Subject: Comments on Recently Received Documents Pertaining to  
Seattle Tacoma International Airport Project  
Third Runway – Low Flow Analysis

GeoSyntec Consultants (GeoSyntec) has been retained on behalf of the Airport Communities Coalition (ACC) to provide a technical review of investigation, analysis and design relating to geotechnical and hydrogeological elements of the proposed Third Runway Expansion Project at the Seattle Tacoma International Airport. GeoSyntec has previously commented on seismic and geotechnical aspects of the embankment fill and Mechanically Stabilized Earth Wall. In my October 2001 declaration in support of ACC's motion for stay, I raised numerous concerns relating to the Port's Low Flow Analysis. This letter presents an expansion on the issues raised in the declaration based largely on review of the November 27, 2001 report by Pacific Groundwater Group (PGG) titled "Port of Seattle - Sea-Tac Third Runway - Embankment Fill Modeling in Support of Low Streamflow Analysis."

Figure 6: Comparison of 1-Dimensional versus 2-Dimensional Flow in Uniform Fill Columns (25 ft thick) with Port Properties

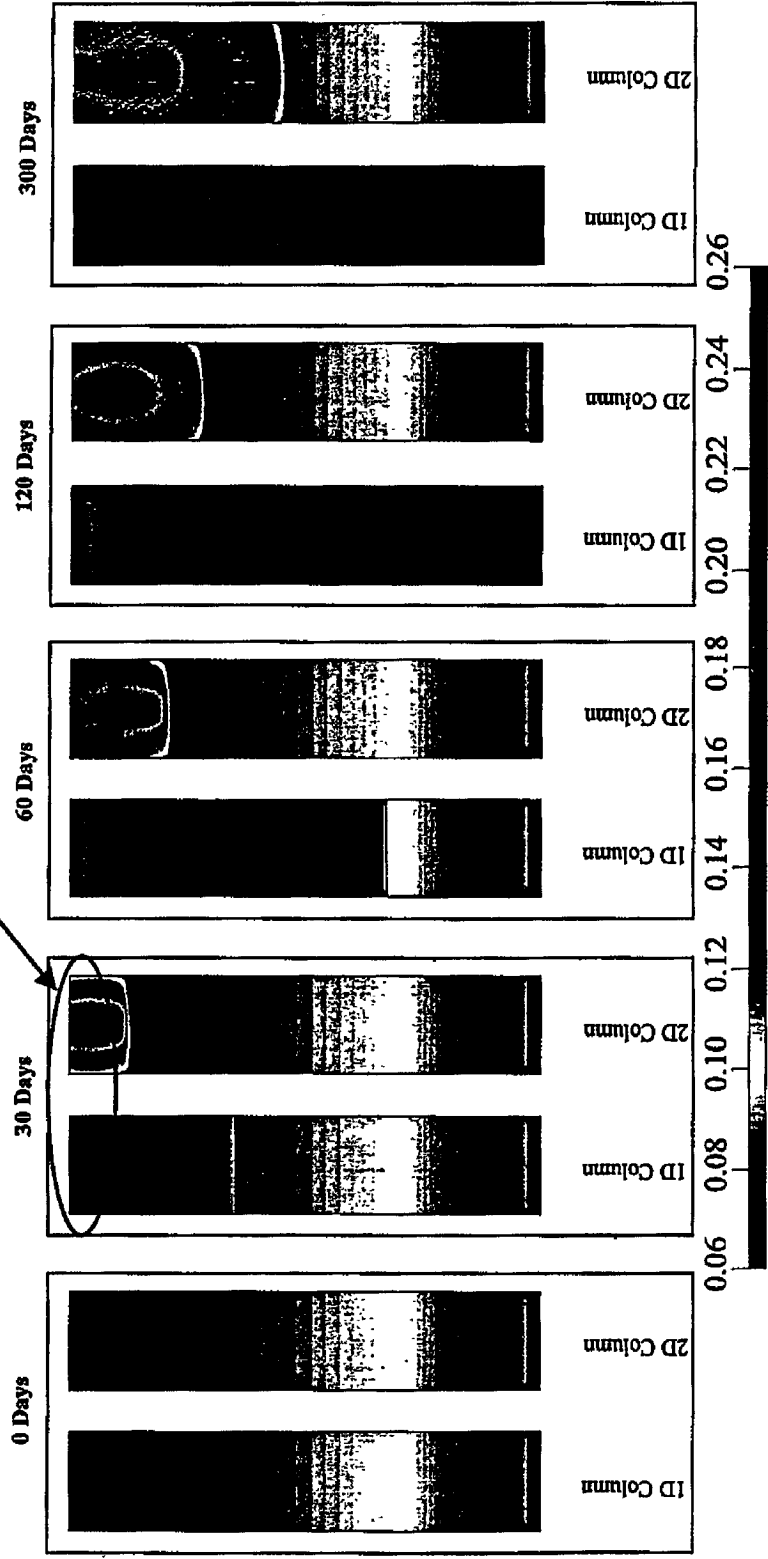
To demonstrate the impact of horizontal flow on the travel time of water flowing through the embankment, two sets of analyses were performed using the Port's soil properties as shown on Figure 6. Two 25 ft thick fill columns were modeled in Hydrus. In the 1-Dimensional (1D) column, water infiltrating at the top of the column travels downward vertically, without an opportunity for any horizontal flow (same analysis as described in Comment 2). In the 2-Dimensional (2D) column, water was applied over the middle 2/5<sup>ths</sup> of the column only, but once the water entered the soil column, it was allowed to travel both vertically and horizontally. This 2-Dimensional scenario is representative of precipitation adjacent to the runway or filter strips (as seen on Figure 5), where water landing directly on the fill surface can pass directly into the embankment, but water landing on the impermeable runway or filter strips cannot.

Comparison of the 1D and 2D columns on Figure 6 makes the impact of horizontal flow immediately apparent. After 30 days, while flow in the 1D column has had nowhere to go but downwards (represented by the advancing dark colored wetting front), flow in the 2D column has traveled downwards and laterally (represented by the dark colored center and lighter colored bands spreading outwards both in front and on the sides of the wetting front). By 60 days, the wetting front in the 1D column has traveled approximately two thirds of the distance to the drain, while the 2D column wetting front has only progressed a quarter of the distance to the drain. This trend continues throughout the analysis, as the 1D column can only send water downwards, while the 2D column continues to allow water to fill in underneath the impermeable regions on either side of the entry point. Clearly, without incorporating this effect into their analysis, the Port is overpredicting the rate at which water flows through the fill, and therefore their estimates of the time at which flows will arrive at the creek will not be representative.
